Building compliance assessment

Design Development Report

Project: S200906 - Recycle Central Group Waste Facility

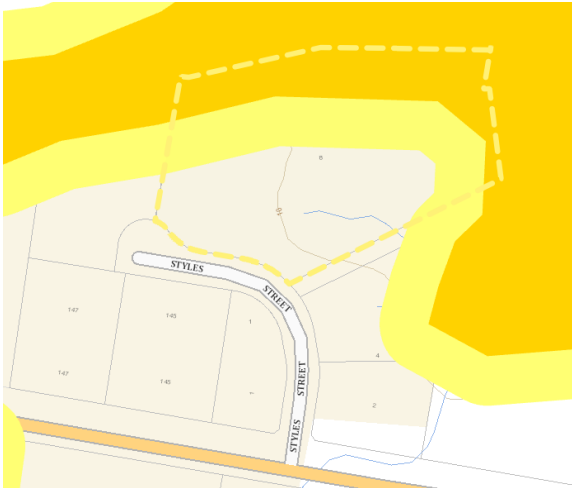
This building is required to comply with BCA D3D17 - D3D21 and D3D29 for fall protection. Details are still being developed but reasonable provision appears to be made for:	Note

a. Balustrades are to be a minimum height of 1m as well as having no climbable elements between the heights of 150mm and 760mm where the floor level is >4m from the falling surface below. The proposed building is a single storey with no areas where balustrades are required. D3D23 - Ladder access to the roof plant shall be constructed in accordance with AS1657-2013. No roof plant is shown on the provided plans. D3D24 & D3D25 - No sliding doors are being proposed as part of this scope of work. D3D26 - Operation of latches are to comply with BCA D3D26 for both doors in path of travel and exit doors (excluding doors to spaces that are inaccessible to persons when the door is locked (eg. cleaners room)). Alternatively, doors may be fitted with an automatic fail-safe device which unlocks the door on activation of any sprinkler or smoke detection system. D3D26 - Consideration should be given to the operation of latch provisions of BCA D3D26 for sliding doors to provide a single hand downward action on a single device. Please note that these requirements will be applicable to facility entrances as plans show provision of fencing and gates that may be lockable.	Note Note Consider Consider
